Energy Networks Association

ENA EREC P28 Issue 2 2018 Key Technical Modifications

Figure CC.6.1.7 Time and magnitude limits for a category 3 Rapid Voltage Change

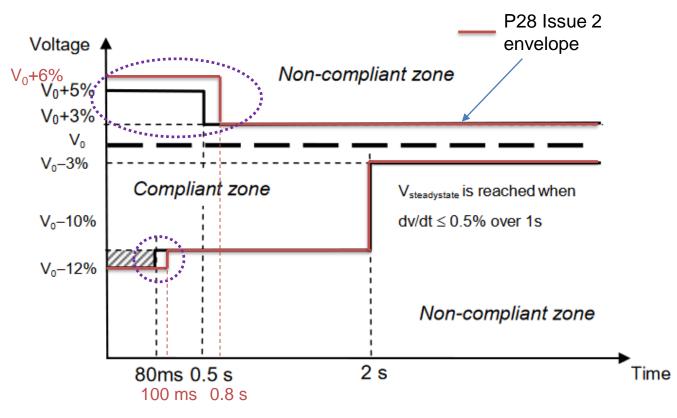
- ΔV_{max} ≤ 5% for a maximum duration of 0.5 s for increases in voltage
- Maximum permitted voltage change of -12% for 80 ms for decreases in voltage Maximum of 4 RVCs in one day typically not planned for more than once per year on average
- No 'Infrequent' events category
- % voltage change based on V₀ not V_n.
